TECHNICAL MEMORANDUM

RE: **INAC REVIEW BY BRODIE CONSULTING LTD ON
MEADOWBANK RECLAMATION COST ESTIMATE,
MEADOWBANK GOLD PROJECT, NUNAVUT**

The purpose of this technical memorandum is to address comments in the report prepared for INAC: Meadowbank Gold Project Reclamation Cost Estimate, by Brodie Consulting Ltd., March 2008 (Brodie 2008).

FIGURE 1

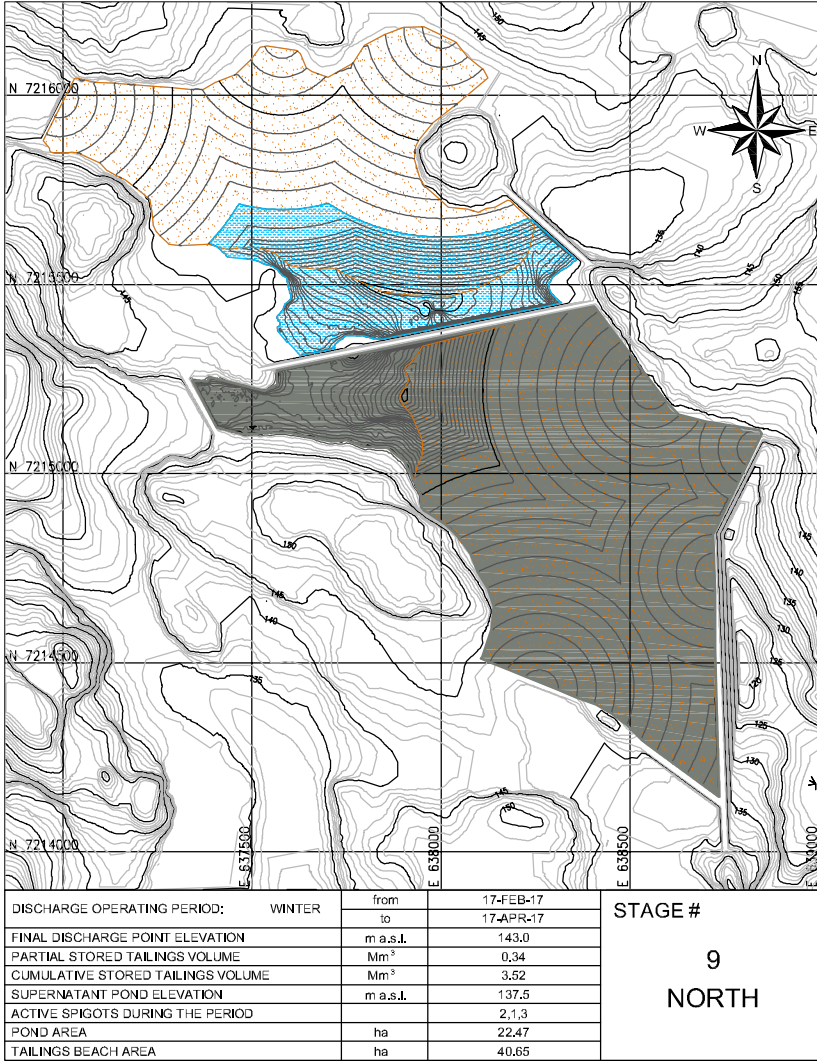
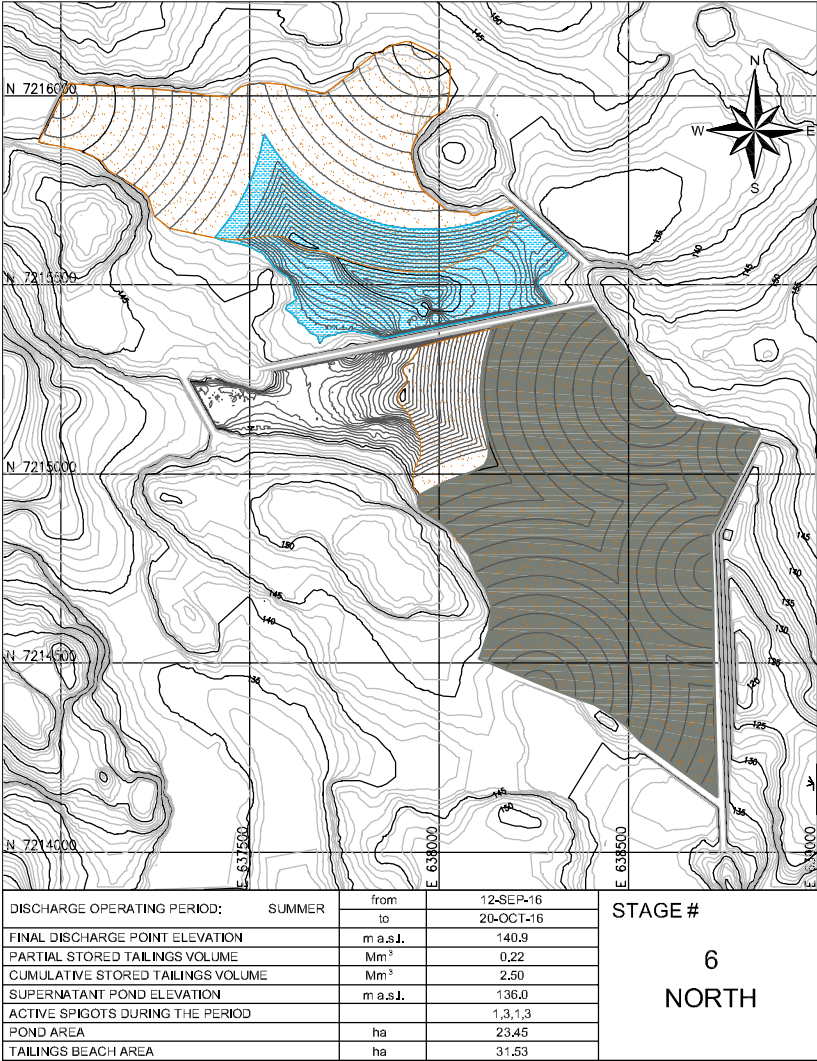
As an assumption for the cost estimate for closure, Brodie (2008 page 6) assumes that no

A sample scenario for progressive reclamation of the south cell of the TSF is illustrated in Figure 1, including volume requirements for rockfill cover and placement rates. Figure 1 illustrates that progressive reclamation is feasible.

The total volume of NPAG rockfill required to cover the south area is 1,625,600 m³. The volume of material is further divided into possible phases of reclamation in Figure 1. Figure 1 illustrates closure of the south cell during operations from year 5.7 to year 7.2.

Closure of the south cell before Year 8, as shown in Figure 1, would require rock placement rates between 2,307 and 3,720 m³/day. This rate may be reduced over longer time frames.
